Discharge of conditions 15, 17,18,19 of full planning permission F/19/86233

Land to the North and East of Boorley Green, Winchester Road, Botley, SO32 2UA

Plan VYH23647 11 Sheet 2 shows the addition of low shrub planting in front of plots 13-19. An extract of the plan showing the plots is as below:

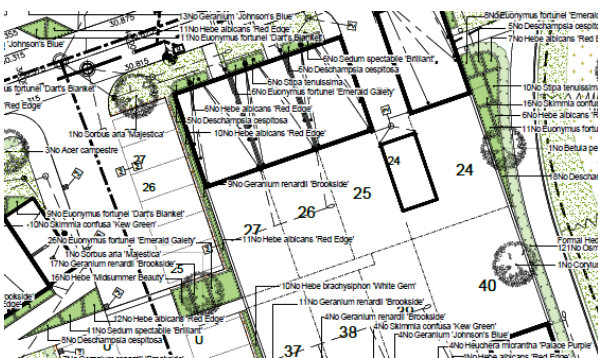
- *Revisions to landscape proposals for retail area as set out in item 5 EBC's Landscape consultation response dated 14.1.21 and provision of benches and bins;*
- *Addition of low shrub planting in front of plots 13-19;*
- *Relocation of tree from rear garden of plot 24 into amenity area immediately adjoining eastern boundary of plot 24;*
- *Additional clear-stemmed tree to north of parking spaces for plot 27.*
- *Provision of knee rail, kerb or bollard detail between the pedestrian / cycle route running north /south through the site and any abutting parking spaces.*

- Landscape Proposals VYH23647 11 Sheet 1

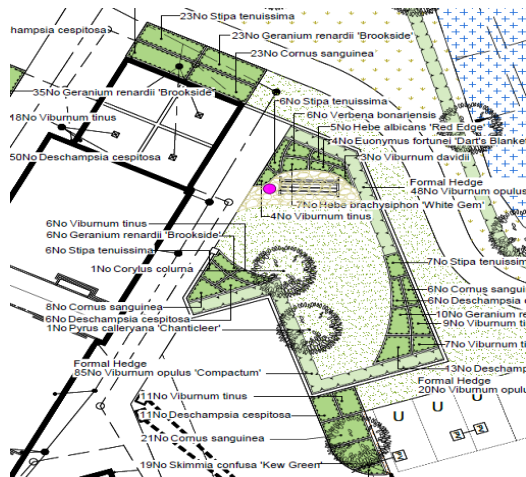
'Notwithstanding the submitted details no development above slab level of plots 1-9 or Block A respectively shall start until details of the private amenity space associated with the respective units has been submitted to and approved in writing by the Local Planning Authority. The spaces shall be designed as a high-quality, private or semi-private garden area rather than a general amenity space and shall include paved seating areas and a variety shrub and perennial planting. Development shall be carried out in accordance with the approved details.'

The extract from plan Landscape Proposal Plan VYH23647 11-1, as shown above, shows that a private space has been created as requested, containing a paved area with seating and a variety of shrubs within the soft landscaping. This therefore discharges condition 17.
